Fig. 703.4.5
Height of Braille Characters Above Floor

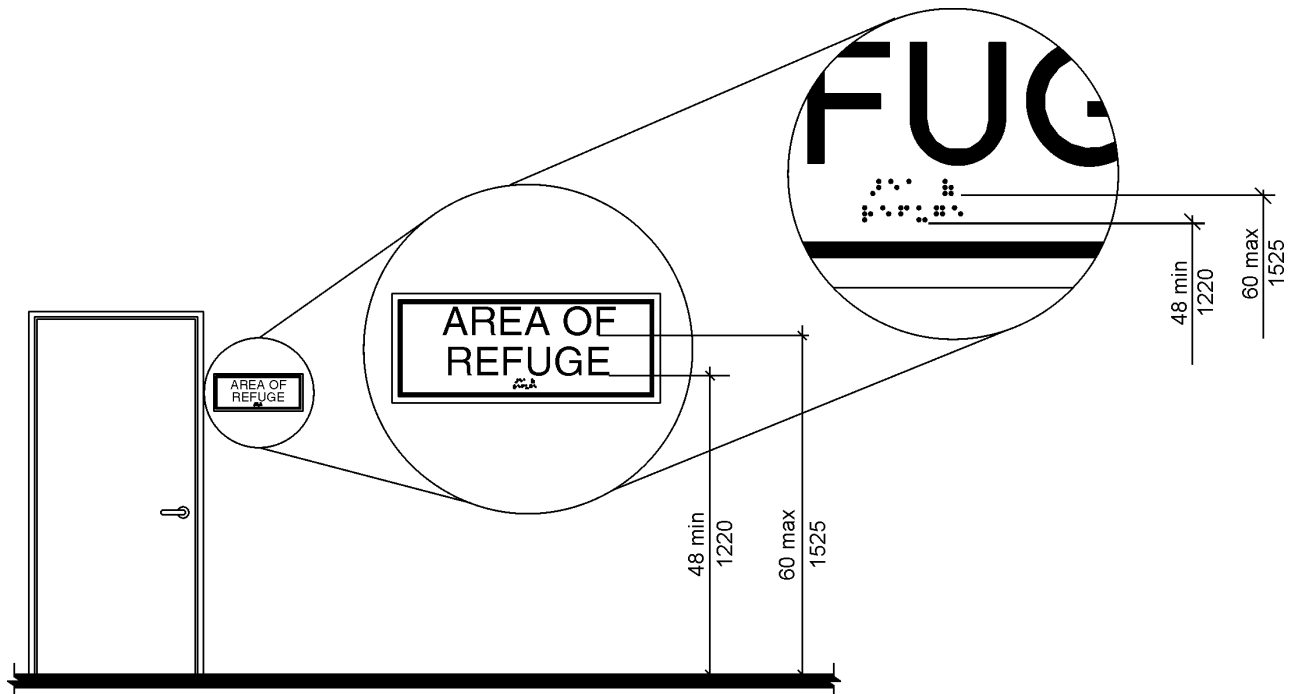
703.4.5 Mounting Height. Braille shall be ~~48~~ 46 inches (~~1220~~ 1168 mm) minimum and ~~60~~ 59 3/8 inches (~~1525~~ 1508 mm) maximum above the floor, measured to the baseline of the braille cells.

Reason: Eliminate a direct conflict between Section 703.3.10 and Section 703.4.5 language and Figures in the definition of minimum and maximum mounting heights of raised characters and Braille.

Section 703.4.4 defines that Braille is required to be positioned below the corresponding text and separated by a minimum of 3/8" (9.5 mm) from any raised characters. Section 703.3.10, requires the height above floor of raised characters to be 48" minimum above the floor, measured to the baseline of the lowest raised character and 60" maximum above the floor, measured to the baseline of the characters. Revision is proposed that will allow Braille placement below the raised characters, as required in Section 703.4.4, and the height of raised characters above the floor to meet requirements of Section 703.3.10 without conflict to Braille mounting height currently required in existing language of Section 703.4.5.

It will not only be physically possible to comply with Sections 703.3.10, 703.4.4 and 703.4.5 if the current language of Section 703.4.5 is not revised as proposed or this section deleted completely.
